Connah's Quay Low Carbon Power

Applicant's Response to Local Impact Report

Planning Inspectorate Reference: EN010166

Document Reference: EN010166/APP/9.15

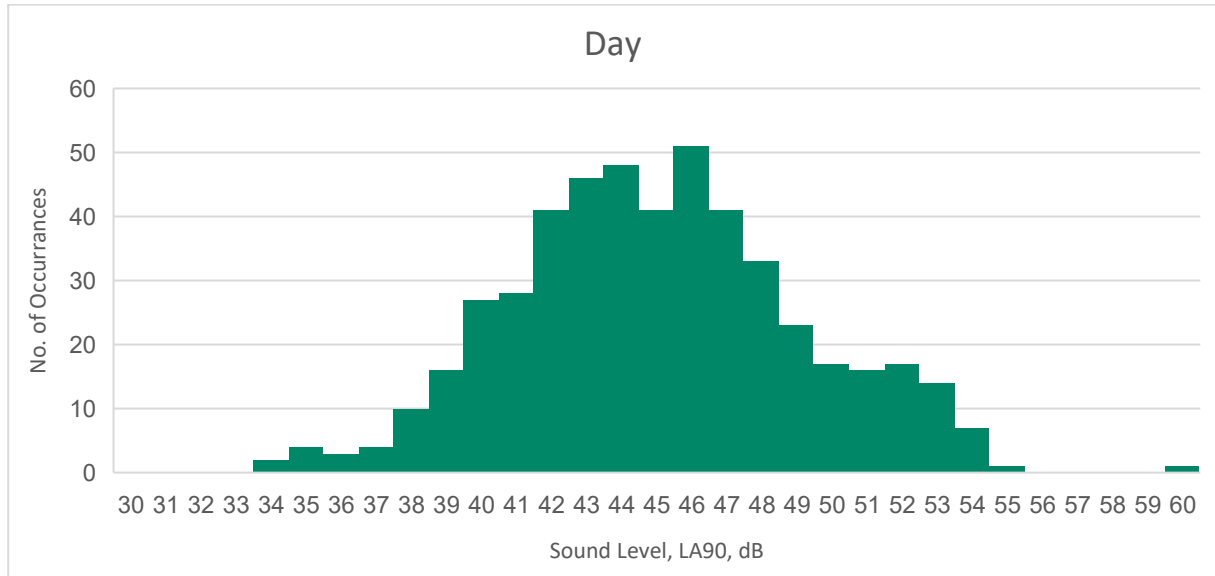
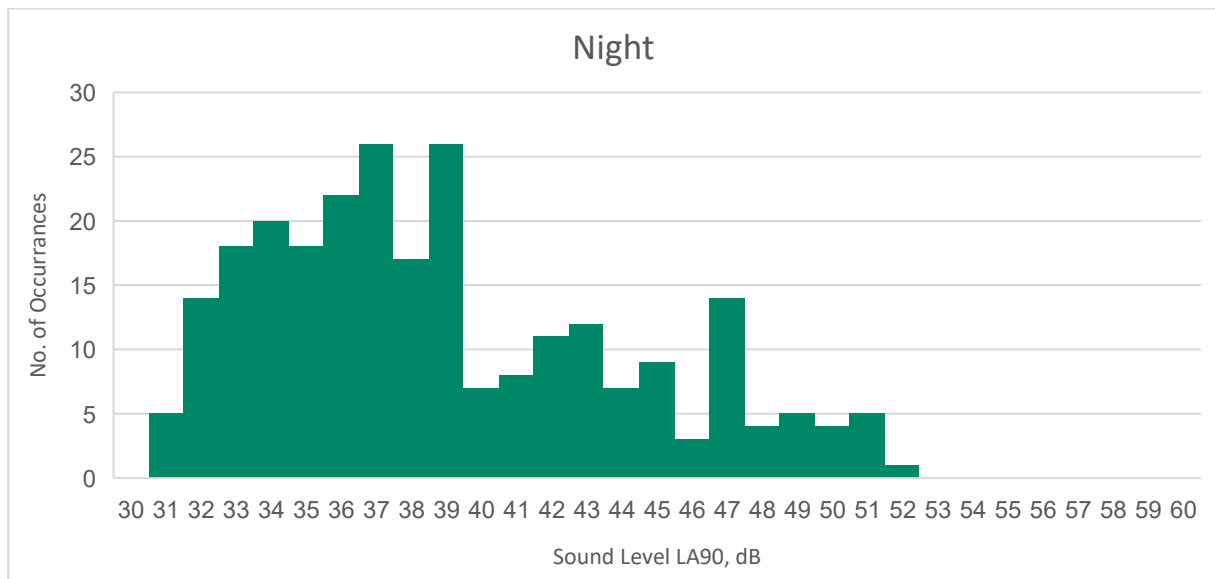
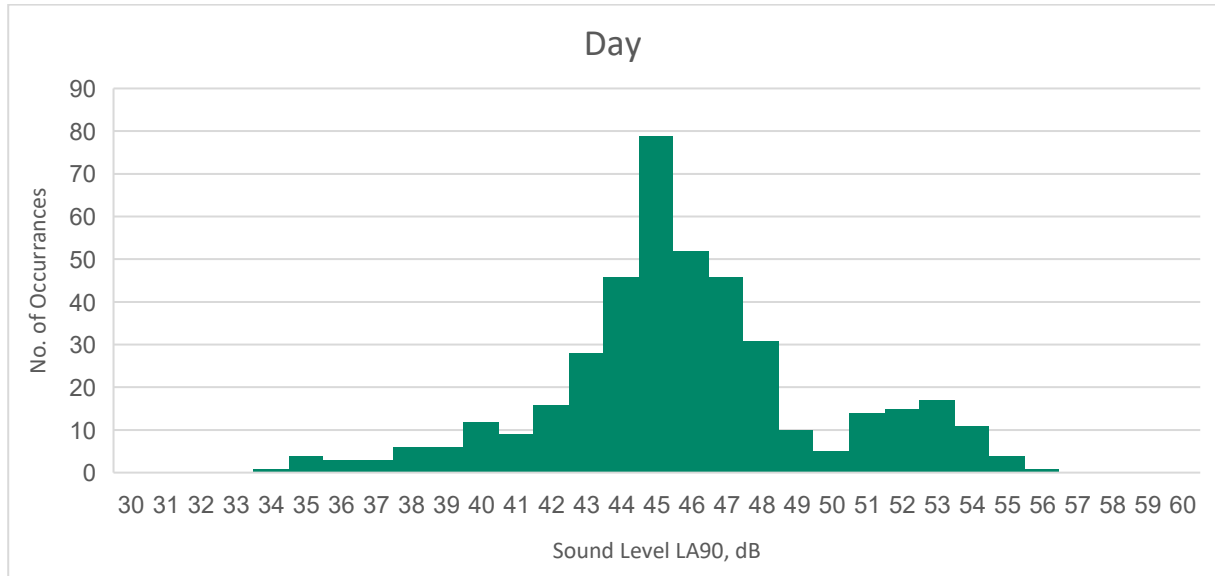
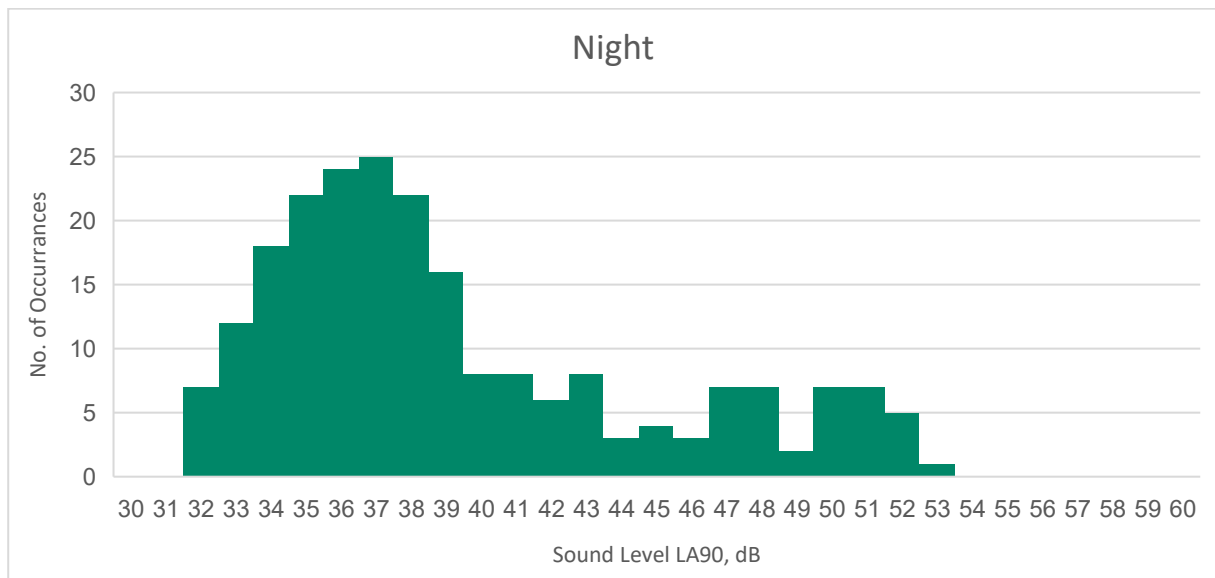
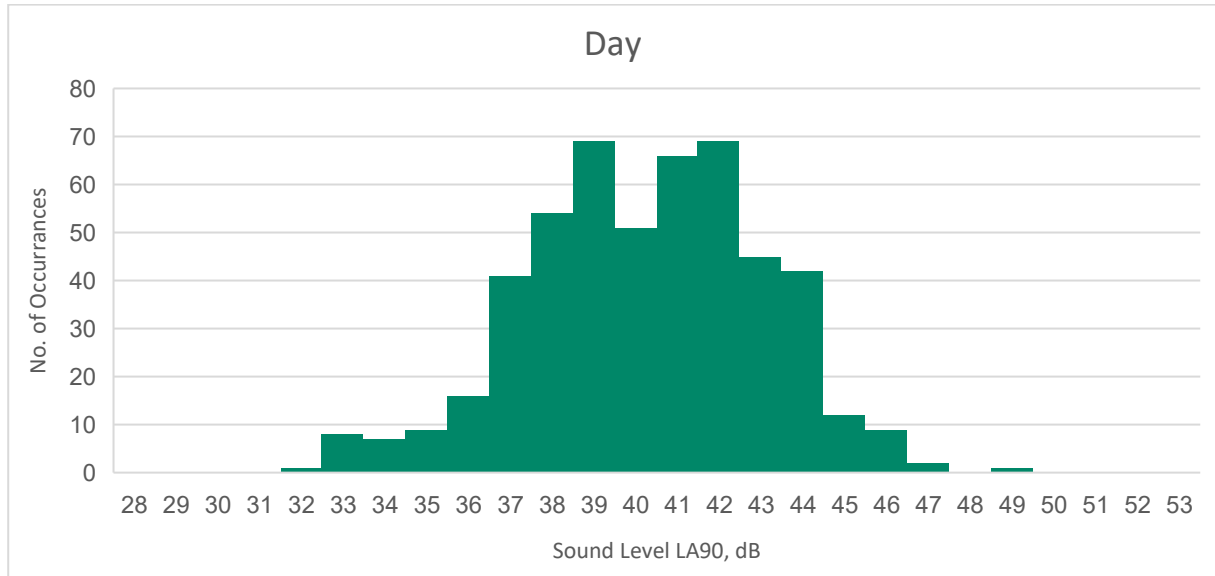
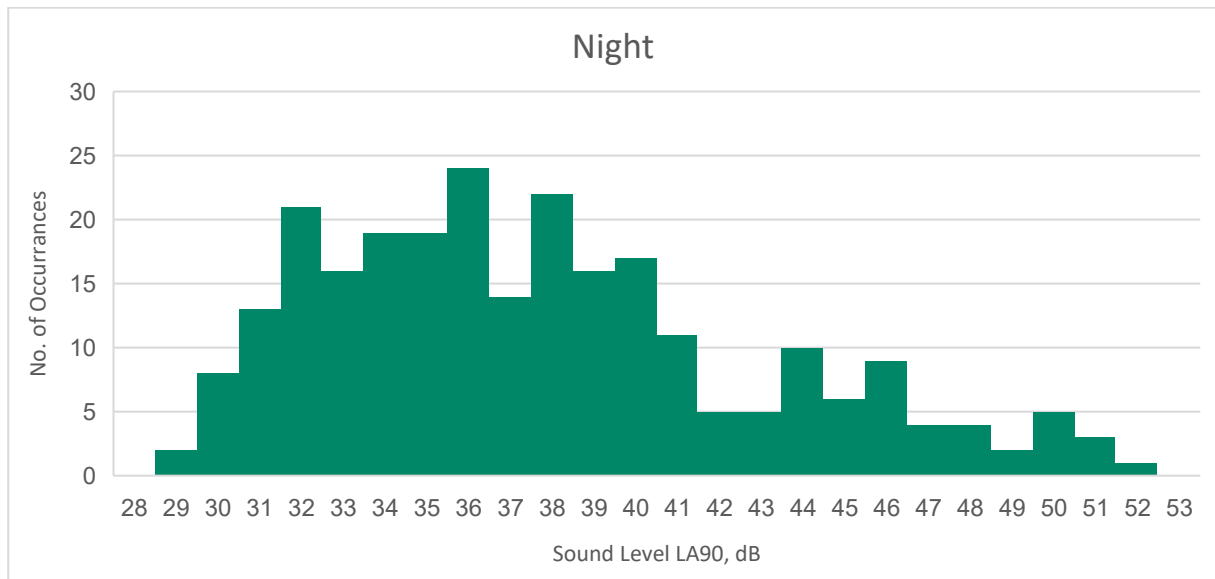
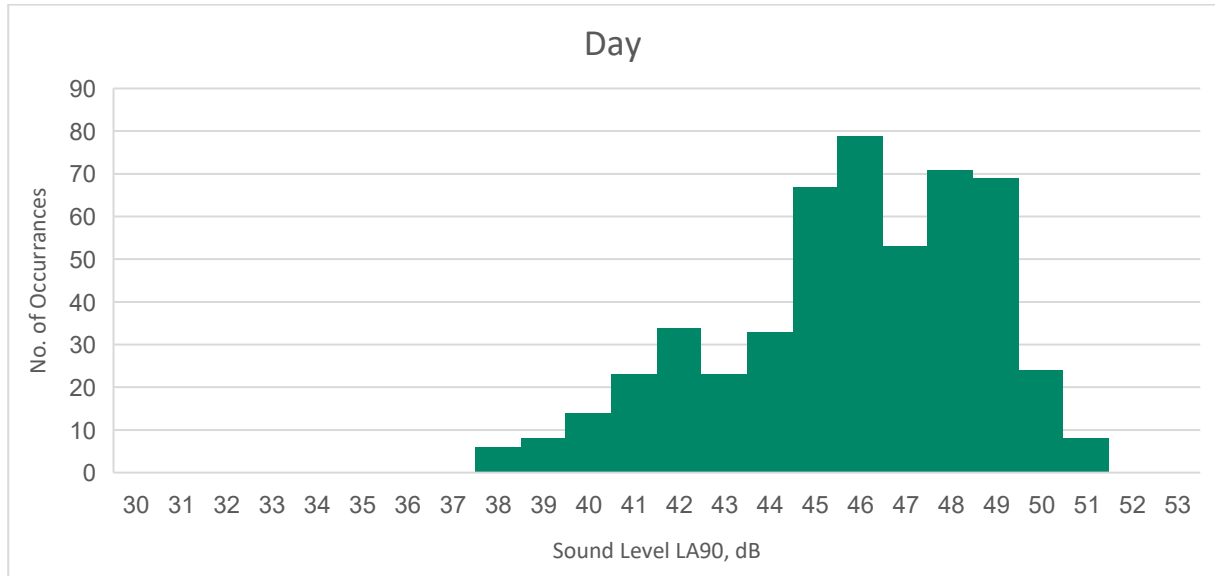
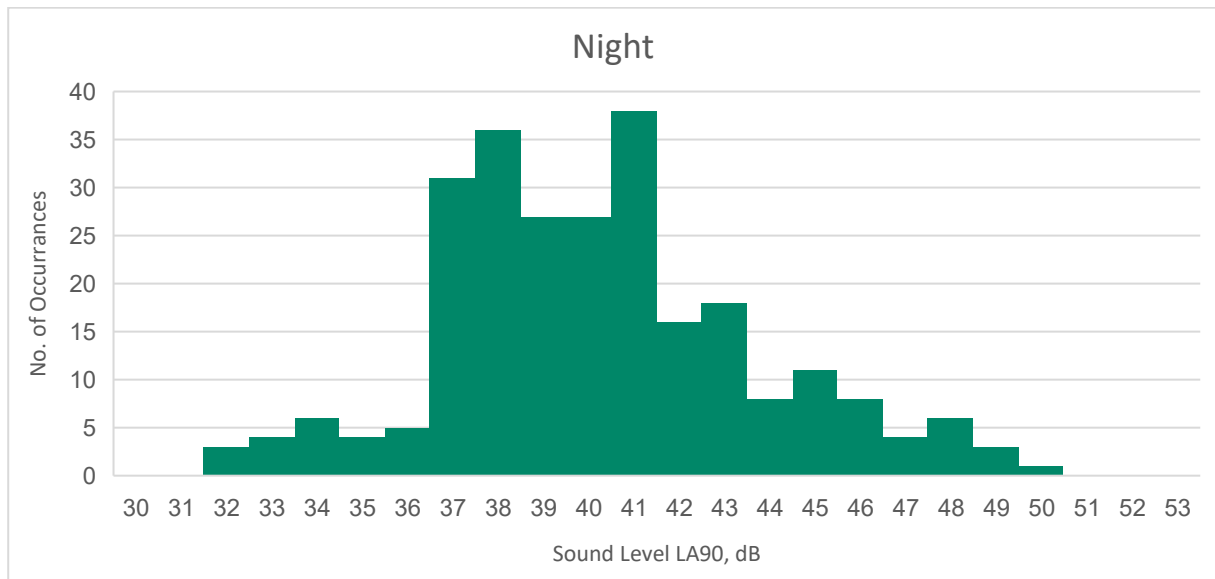
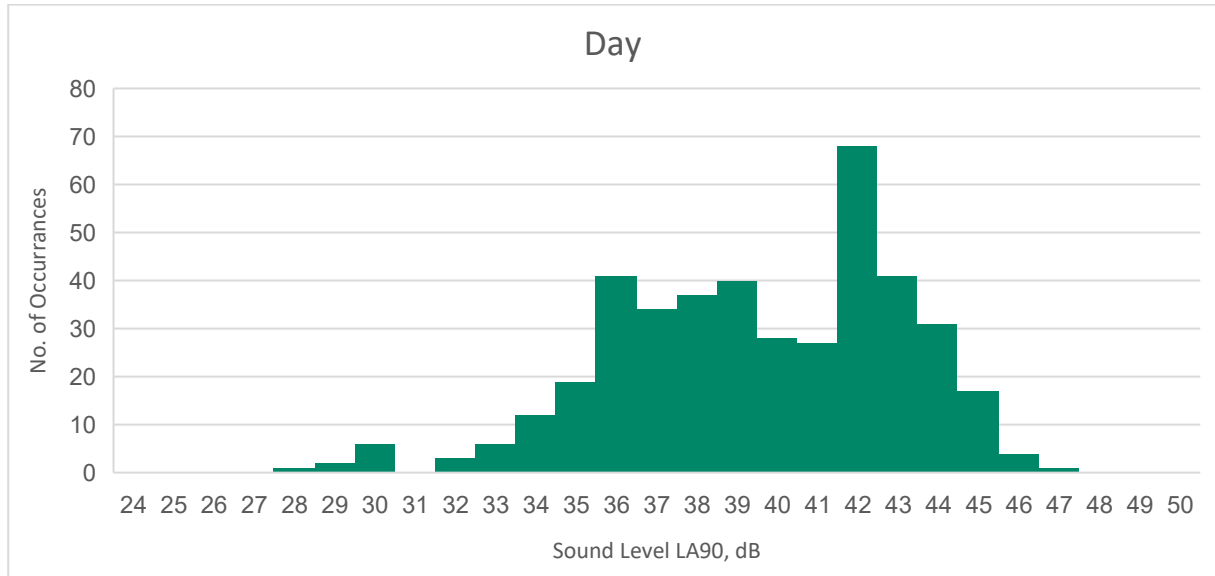
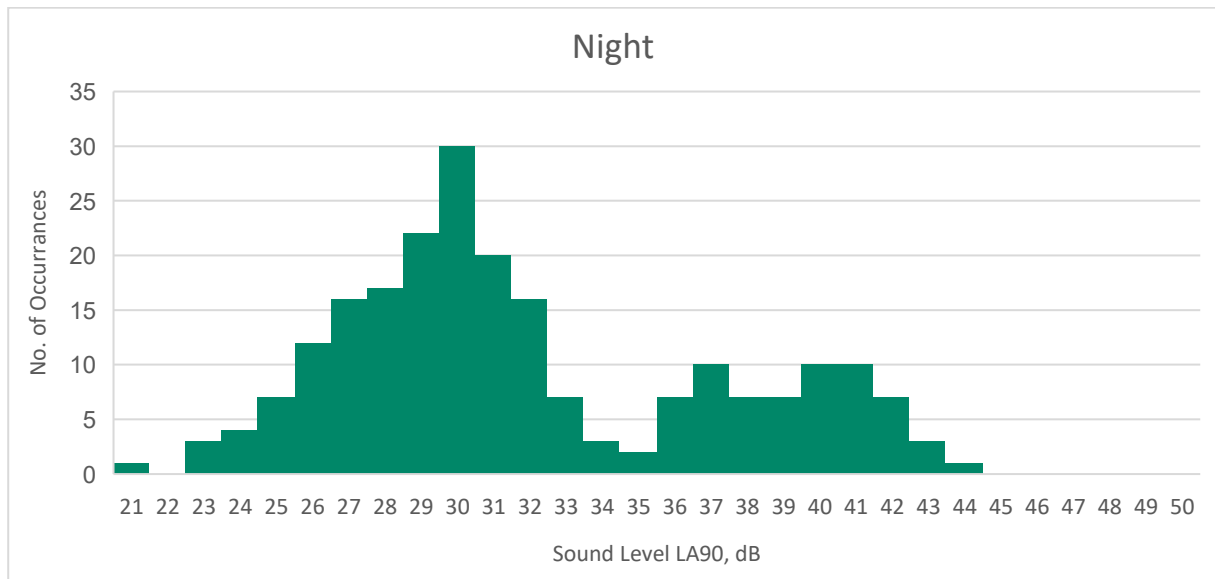
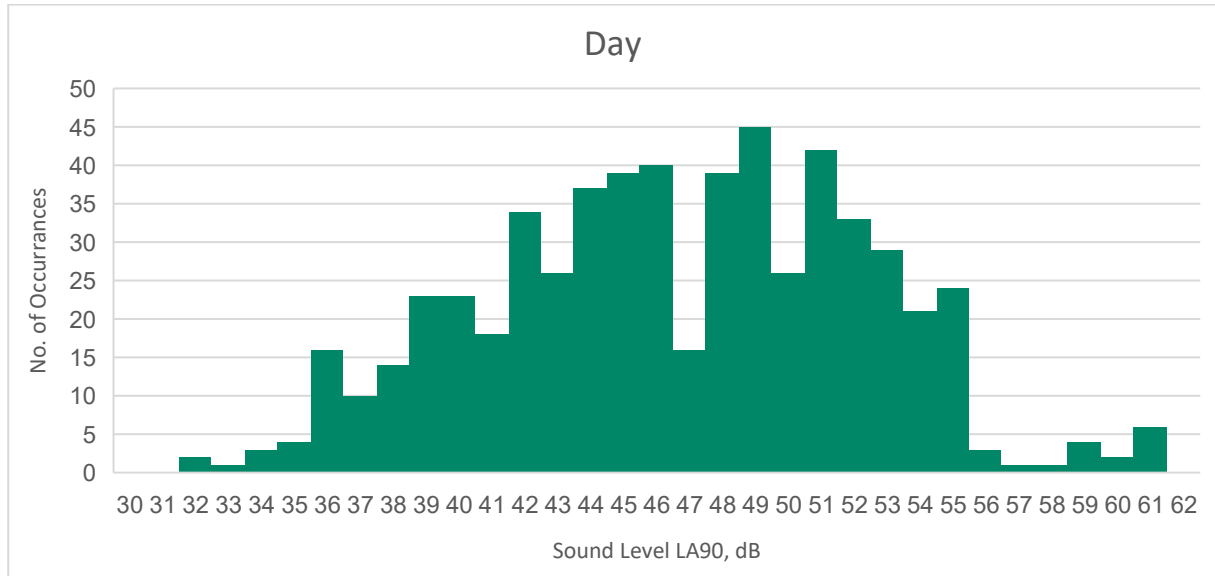
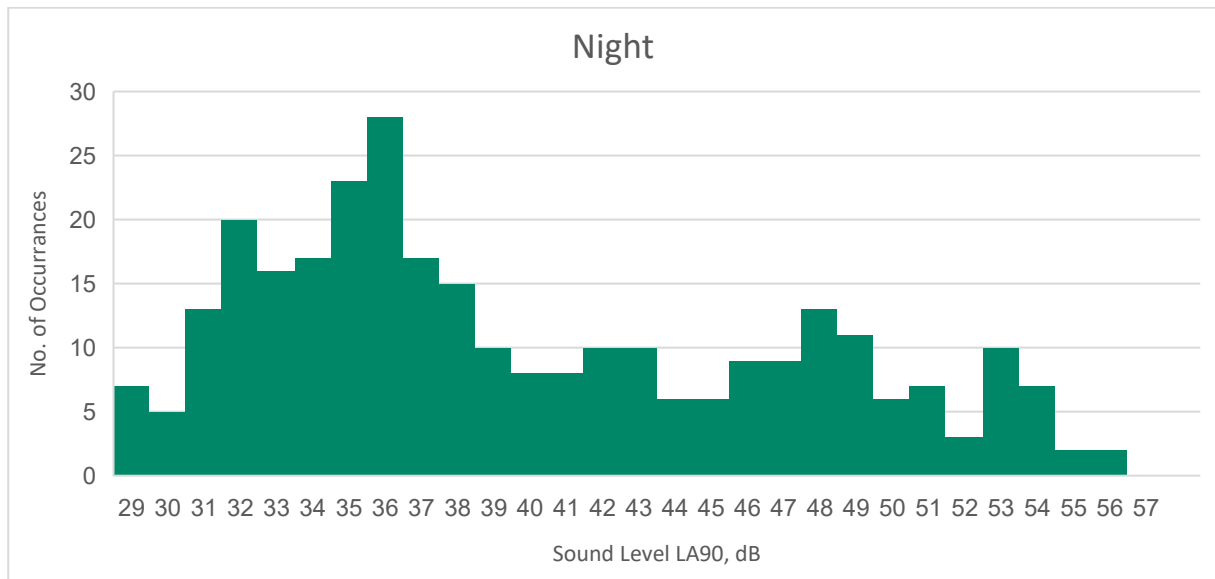
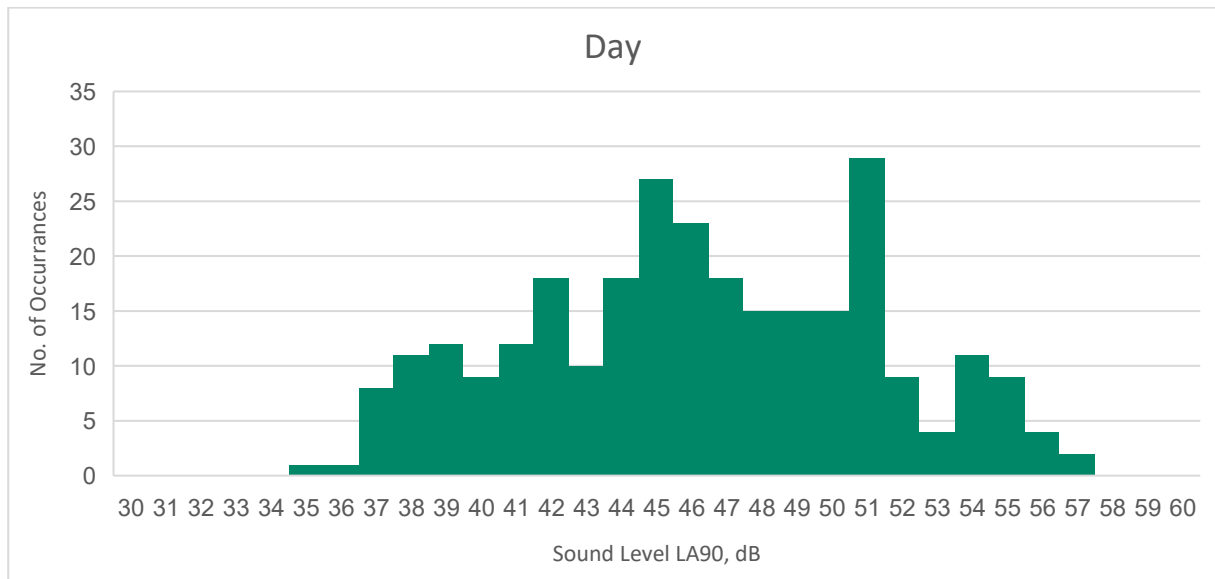
Reference	Source Document Text	Applicant's Response
10.8	A baseline sound survey has been undertaken combining long-term and shortterm measurements. The measurement locations (shown in Figure 9-1 [APP- 120]) are appropriately distributed in relation to noise sensitive receptors and the proposed development site to provide a sufficient representation of the sound environment.	the histogram plots that show the distribution of the L_{A90} data in Appendix A of this document.
